CERTIFICATE OF APPROPRIATENESS

Property: 841 Arlington St.- Lot 2, Block 249 Houston Heights per HCAD.

Proposal: Exterior restoration, interior renovation, and a rear two-story addition.

Recommendation: Approval

1 PROPOSED SITE PLAN
1/8" = 1'-0"

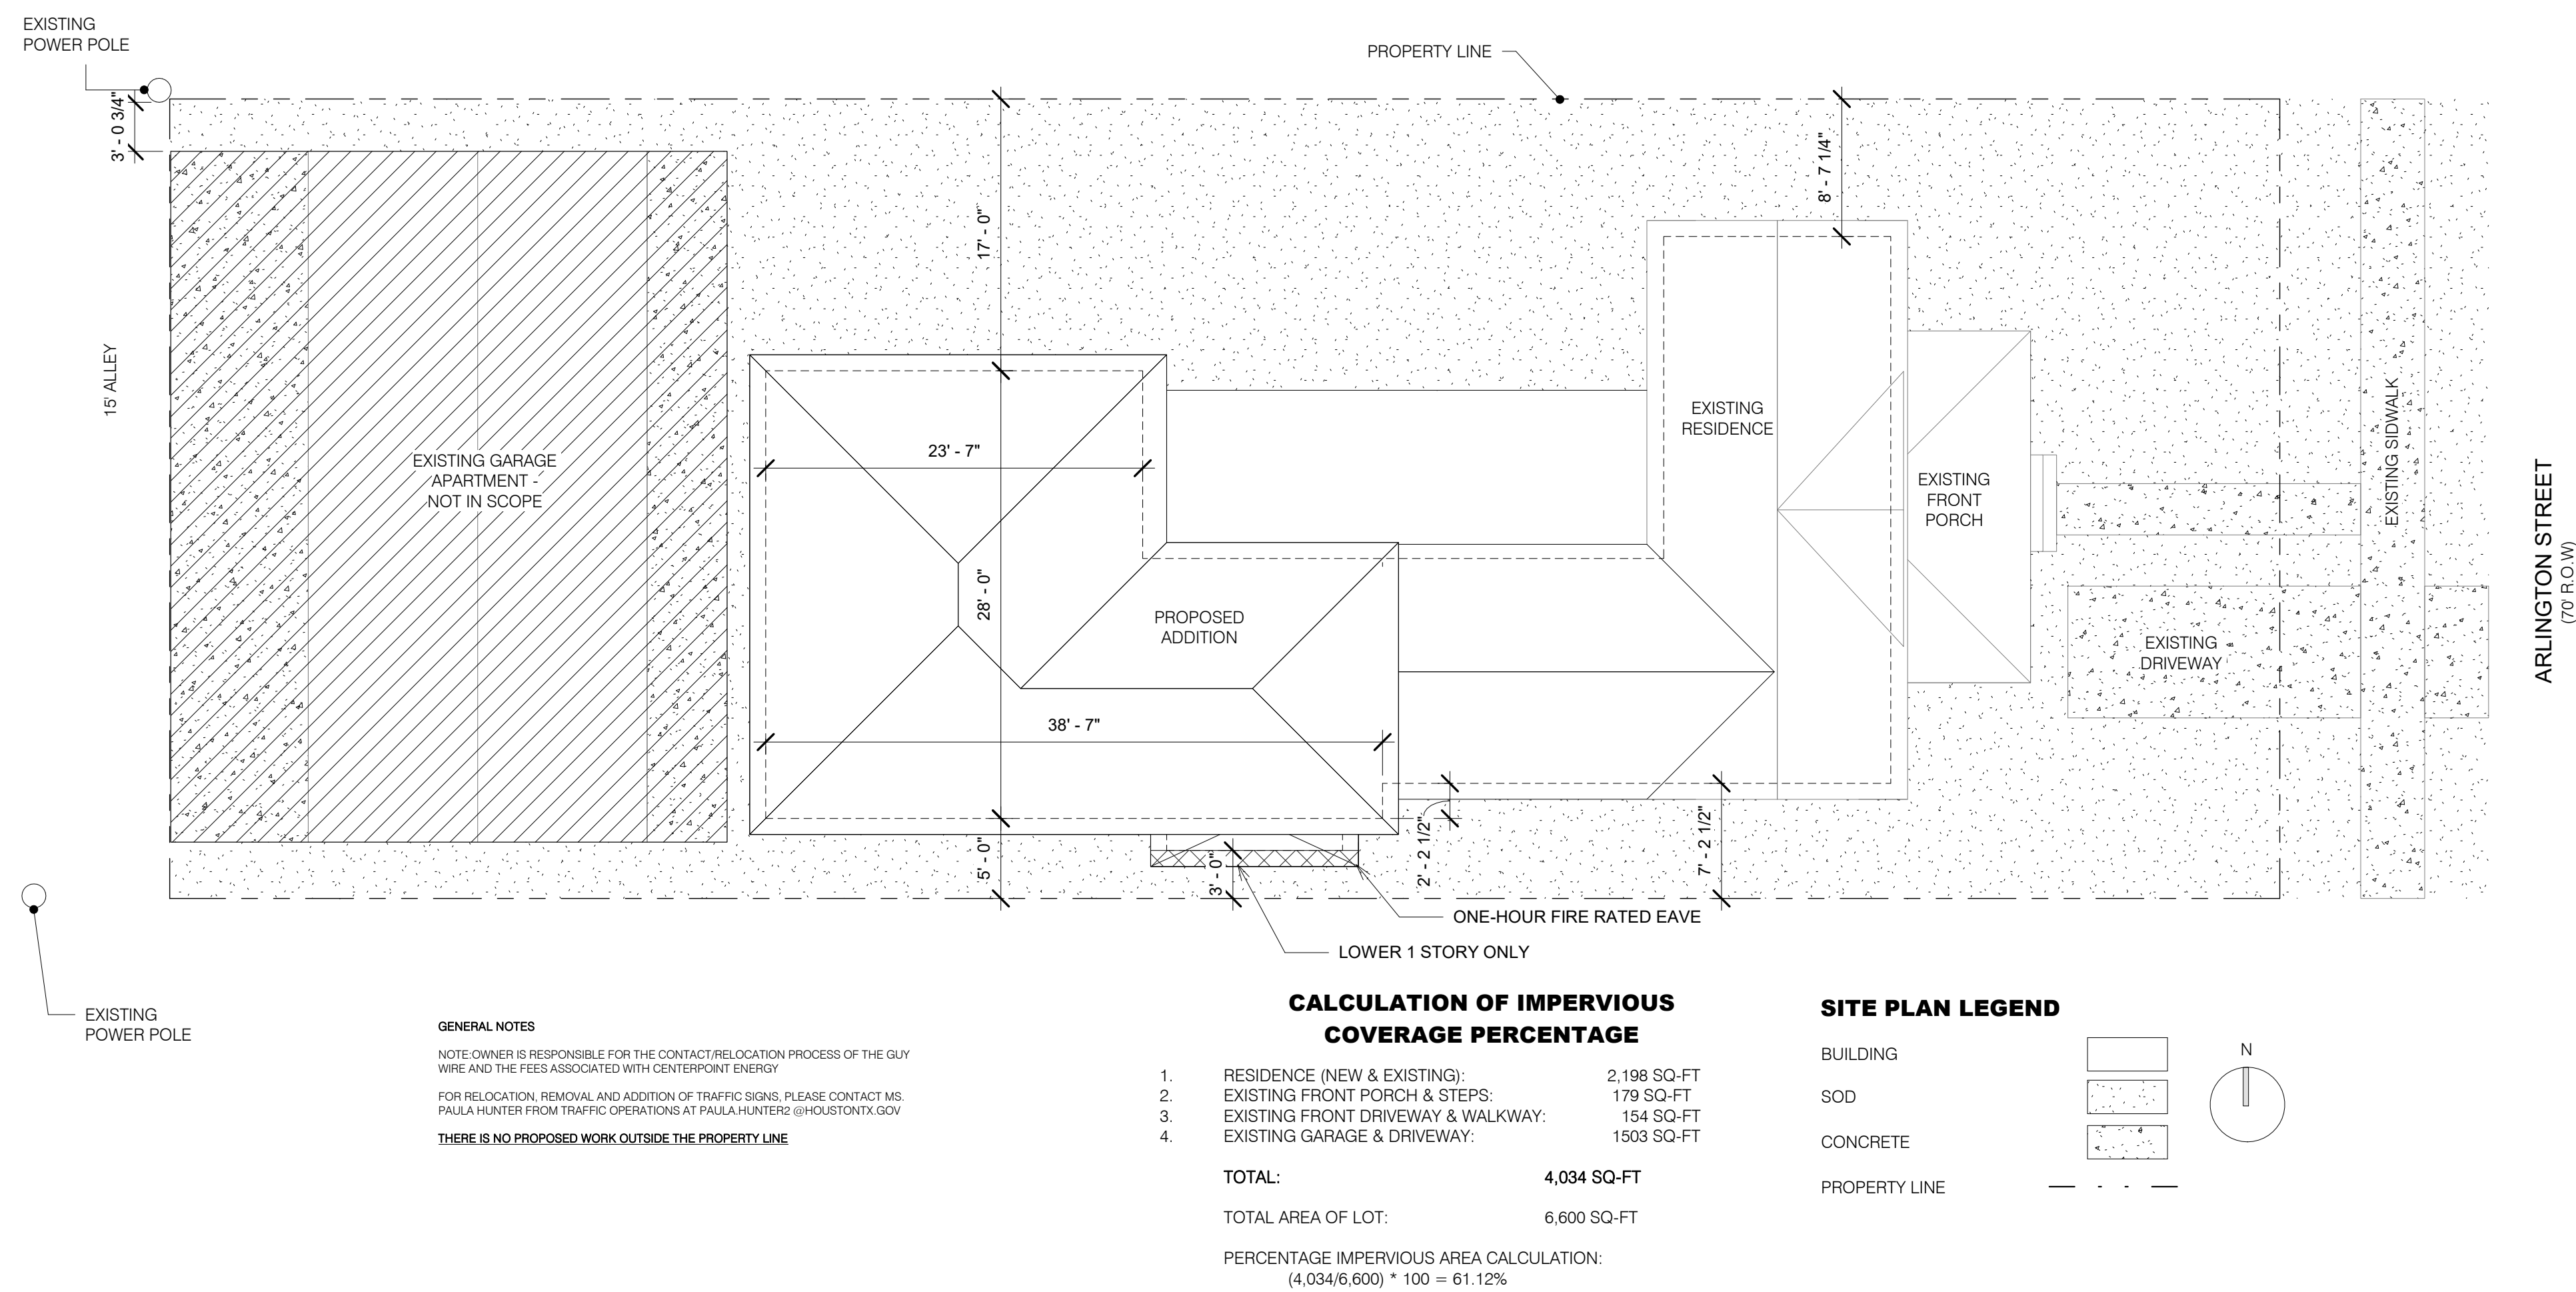
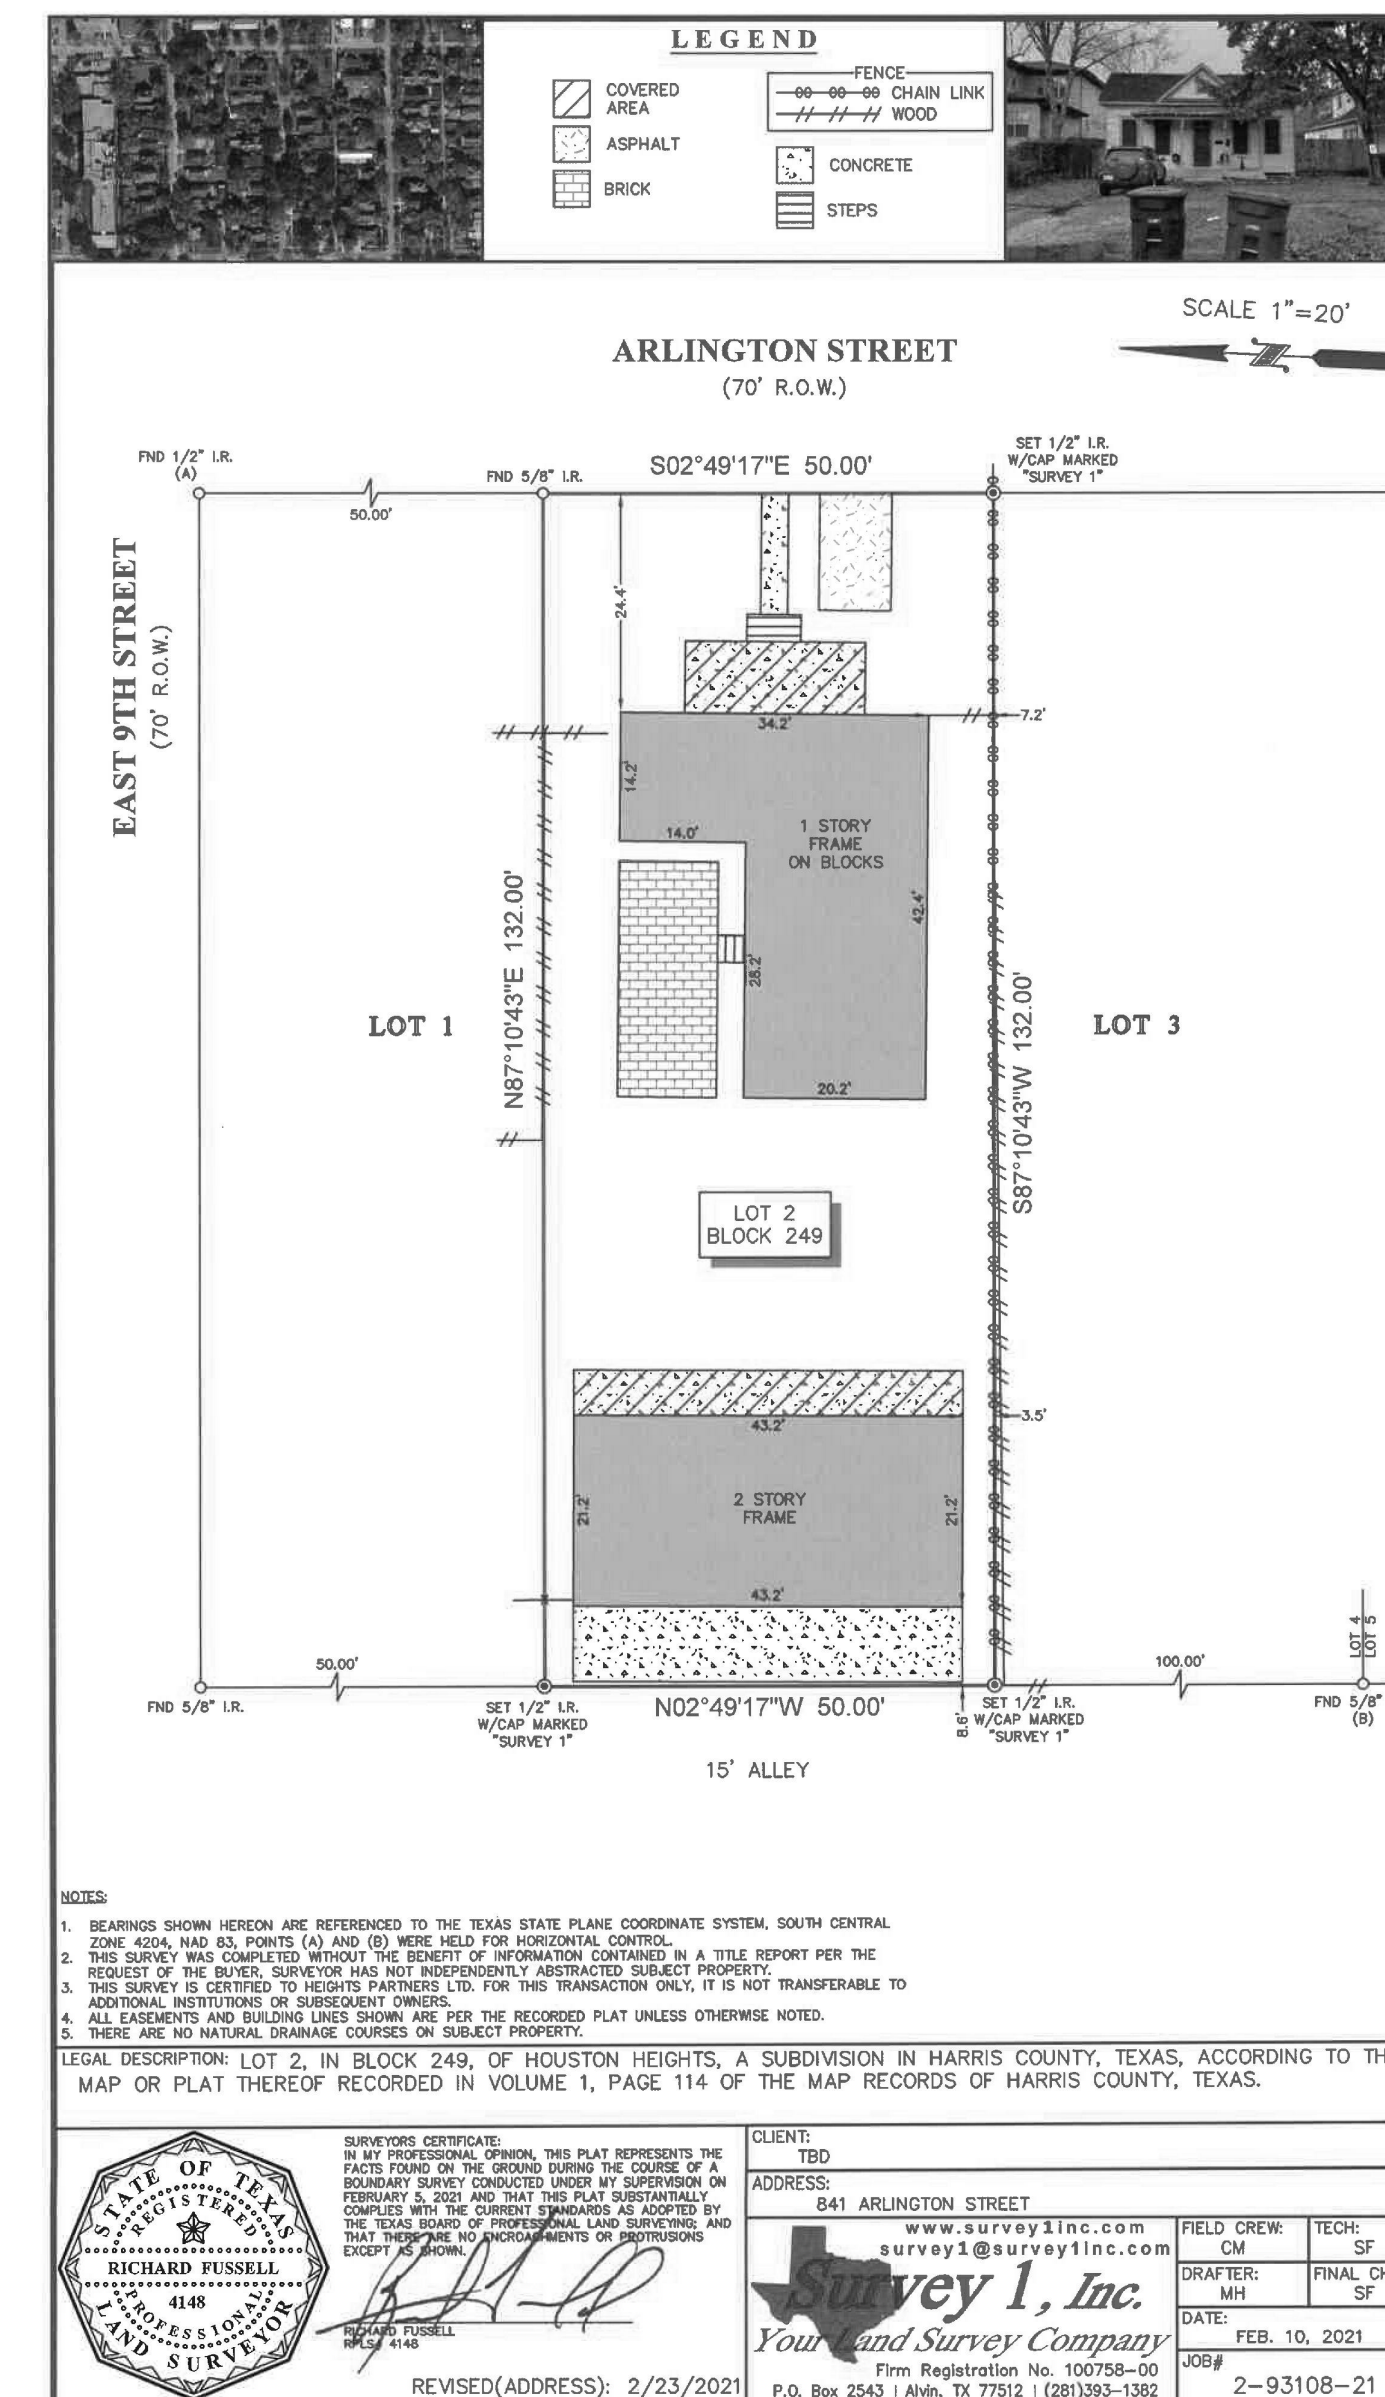
The maximum lot coverage is 2,640 SF and the proposed project would have 2,052 SF.

The proposed project has a 1-story side projection that is within the 5' setback which violates this measurable standard. The proposed design would allow a contemporary use without compromising the historic plan of the house and its relationship to the site. Staff believes the intent of the guidelines is met with in the proposed project. The cumulative setback requirement of 15' is met as the cumulative setback of the proposal would be 20'.

The maximum allowed SF is 2,904 SF and the new proposed structure including the garage will be 2,841 SF.
